PHASE I INSPECTION REPORT

NATIONAL DAM INSPECTION PROGRAM

Name of Dam: Meherrin River Dam at Emporia

Date of Inspection: 19 April 1978

DATE:	9-6-74	DAM CROSS SECTIONS EMPORIA DAM - EMPORIA, VA.	COMM. NO. 3010
DRAWN BY:	RLC		NUMBER: SK-1
APPROVED BY:	W.B.N.	WILEY & WILSON, INC. LYNCHBURG, VA.	SCALE: 1" = 20'

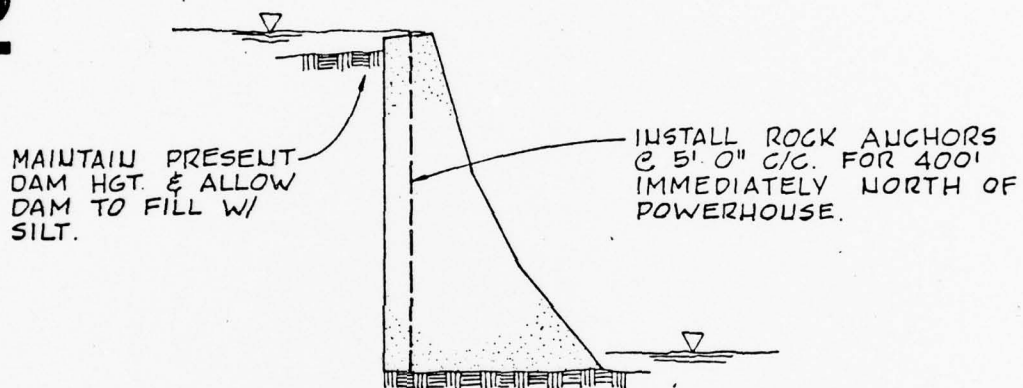
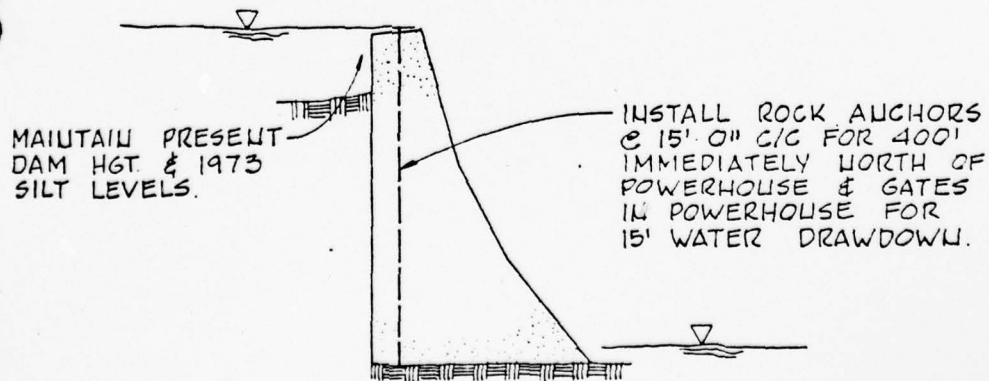
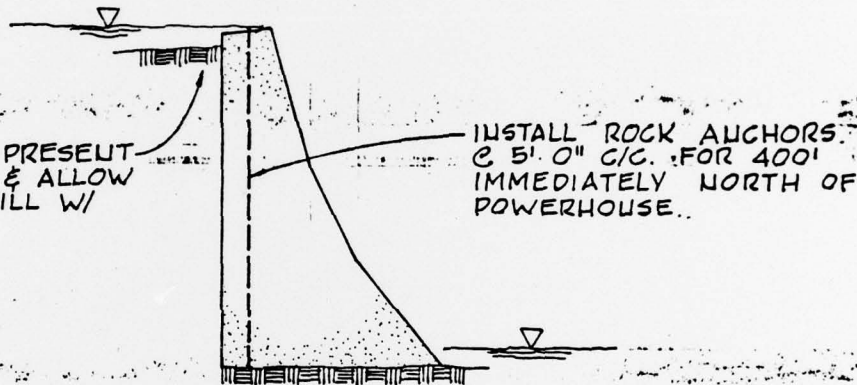
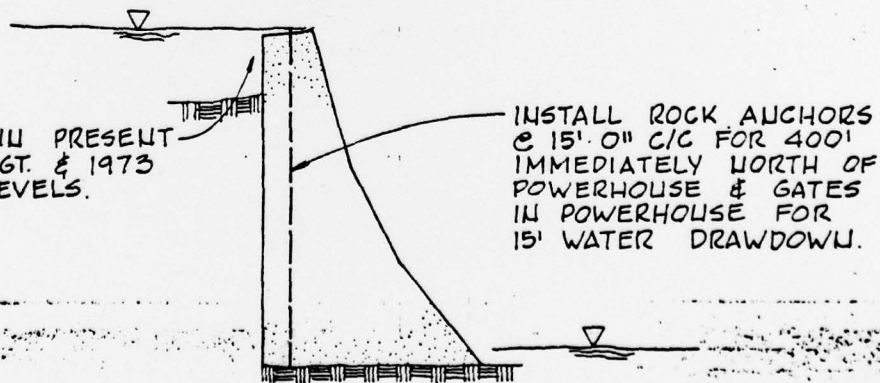
6.3.2 The stability analysis performed by the owner's consultant and the ensuing remedial measures have many aspects which neither conform to the Corps of Engineers criteria nor the state-of-the-art in dam design. These aspects are discussed in detail in the following paragraphs.

6.3.2.1 The vertical and horizontal cross sectional dimensions used are not consistent with the core borings. The analysis uses a bottom elevation of 73.3. Many of the boring logs establishes the concrete-rock contact between elevations 69 to 71. In this type of remedial analysis, the most conservative figures should be used.

6.3.2.2 Uplift considerations have been ignored throughout the analysis. Design criteria differ in the amount of uplift to be considered in a stability analysis, but all criteria agree that uplift must be included. The Corps guidelines require total uplift be used in a stability analysis. Visual observations of the dam (seeps, severely weathered exterior, etc.) and core borings indicate that the dam and foundation rock contact is severely weathered in several large areas. Therefore, the condition of this dam requires full uplift be used in the stability analysis.

6.3.2.3 The maximum flood condition considered assumes a headwater 5.5 feet above spillway elevation of 111.8. Tailwater is neglected. This condition is less than a 100 year event and, also, less than the largest known flood of record, 1940, which had a recorded headwater 7.6 feet above the spillway. Under Corps criteria, the dam is classified intermediate size, high hazard and should be analyzed for the probable maximum flood (PMF).

6.3.2.8 The analysis assumes the silt will remain at its present level. Even though the owner's consultant recommended the installation of gates which could be used to flush the silt periodically, this plan has not been implemented. For purposes of stability analysis, siltation should be assumed to increase until measures are instituted to control silt levels.

DATE:	9-6-74	GATE INSTALLATIONS & EXIST POWER HOUSE EMPORIA DAM, EMPORIA, VA.	COMM. NO. 3010	
DRAWN BY:	REC		NUMBER:	SK-2
APPROVED BY:	W.W.	WILEY & WILSON, INC. LYNCHBURG, VIRGINIA	SCALE:	NONE

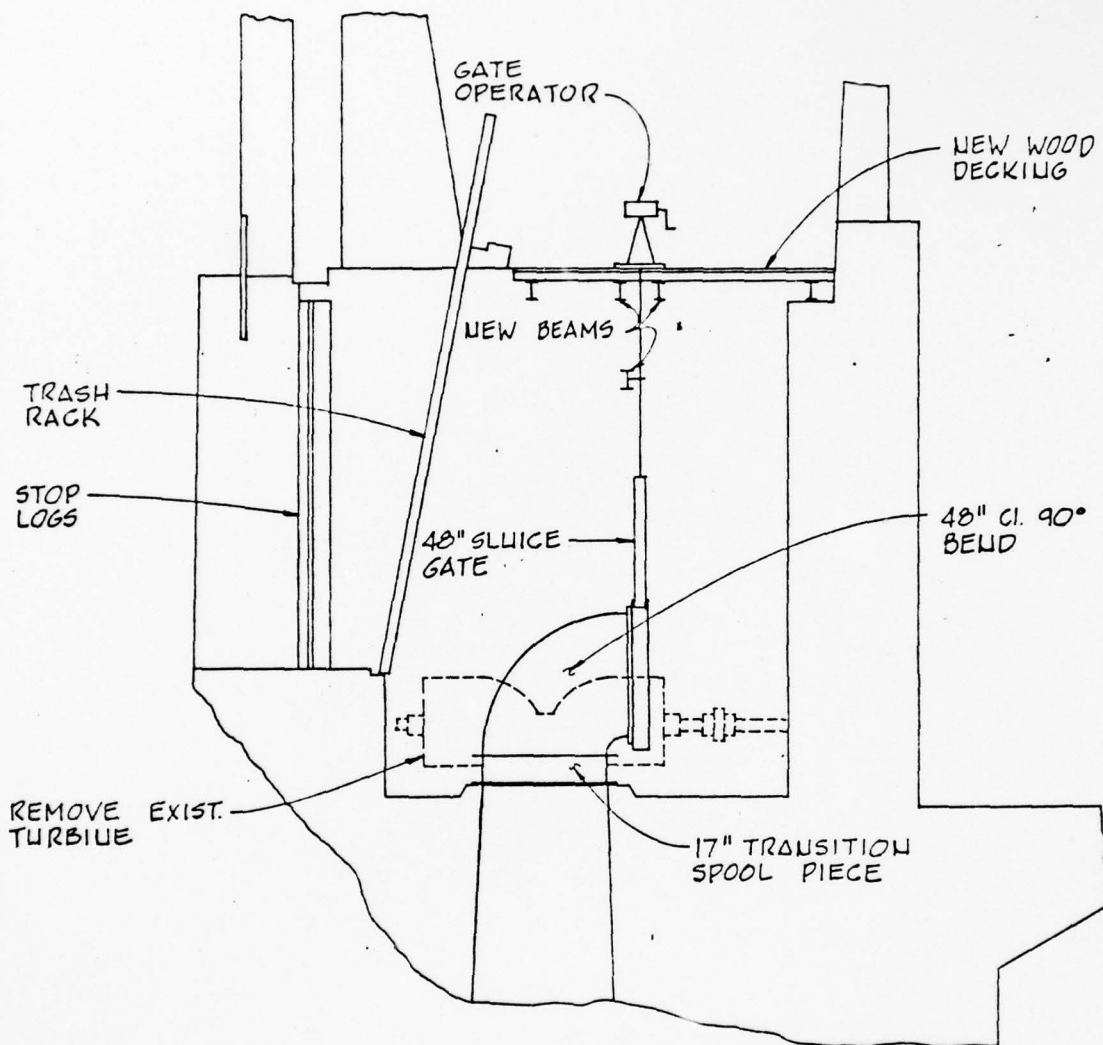
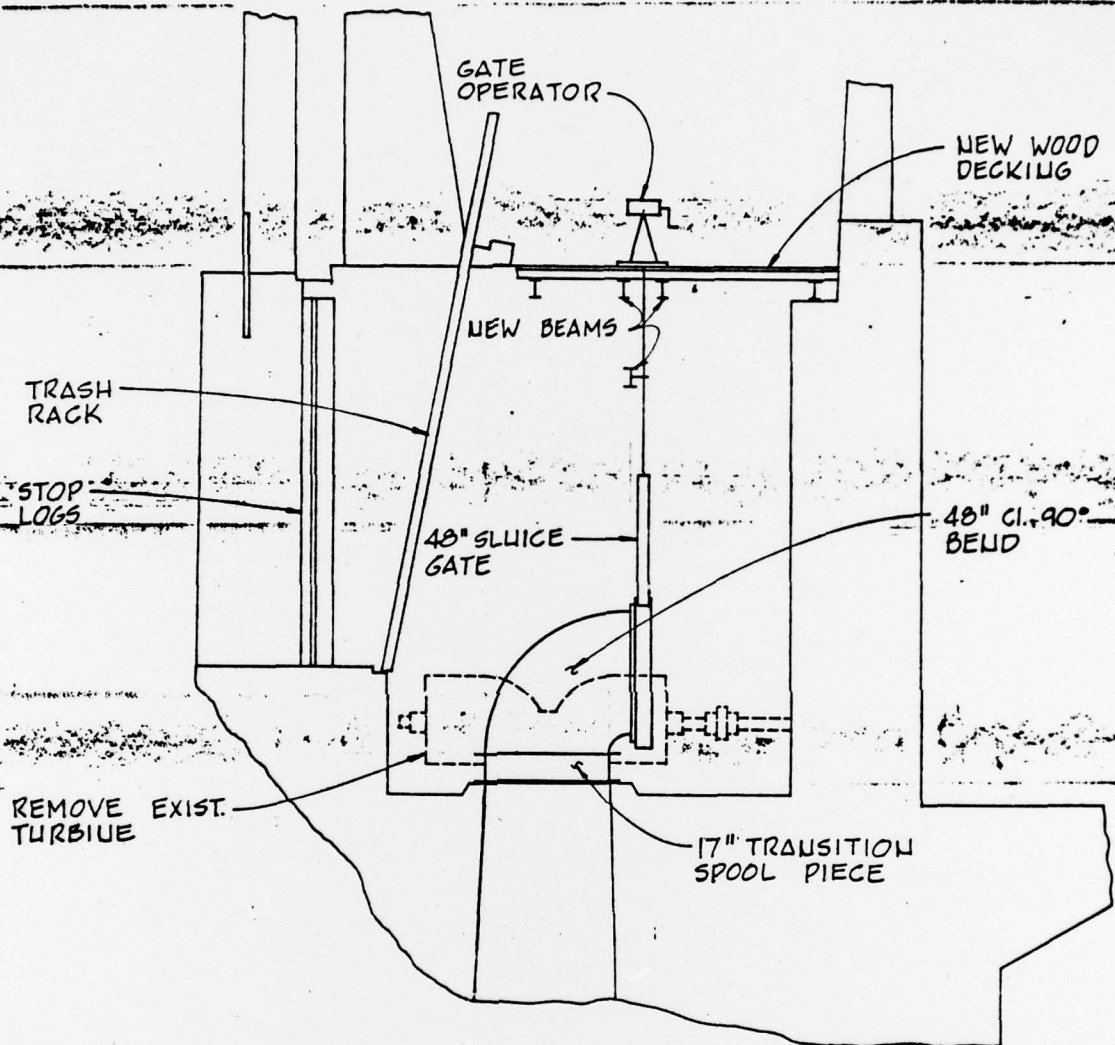
To provide for the ability to control the lakes level install sluice gates as illustrated in sketch (SK-2) at bays 4 and 5. Bay 4 and 5 are the two bays at the south end of the power house. Repair the leaks between the turbine bays and the generator room. Drill three or four 6-inch diameter holes thru the generator room floor to drain the standing water and prevent future pooling of water.

7.2.4 Remedial Treatment: It is recommended that the sluice gates recommended by Wiley & Wilson be installed as soon as possible to provide a positive means of lowering the reservoir level and controlling the level of siltation. Erosion adjacent to left abutment should be corrected as soon as practical.
